MS-15-00215: A Minor Subdivision Replat of Lots 19 & 20 of Commerce Park East located at 1100 & 1200 E 25th Street. Submitted by Grob Engineering Services, LLC for Roger D. Johnson, Hedge Tree, LLC, property owner of record.

ADMINISTRATIVE DETERMINATION: The Planning Director approves the above-described Minor Subdivision, subject to mylar and recording fees for this Minor Subdivision, and the following condition:

Figure 2. Proposed lot split and easements in yellow

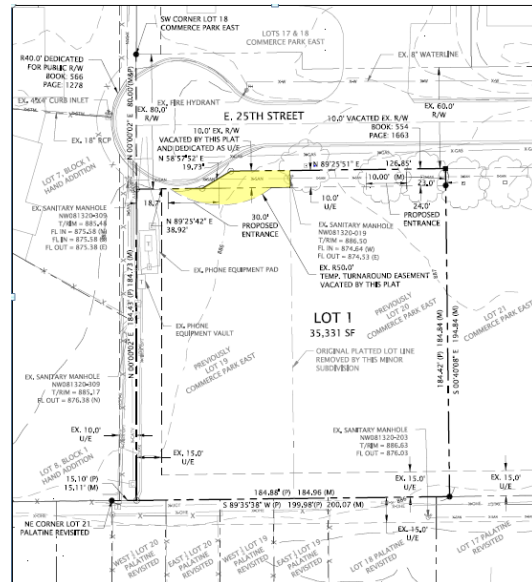
The western portion of East 25th Street was originally platted with 80 feet of right-of way, of which, 10 feet is being vacated by this Minor Subdivision and dedicated as utility easement associated with an existing sanitary sewer main. There is also an existing 50 foot temporary turnaround easement vacated by this plat. The City Commission is scheduled to receive acceptance of dedication of utility easements and vacation of right-of-way on June 9, 2015.
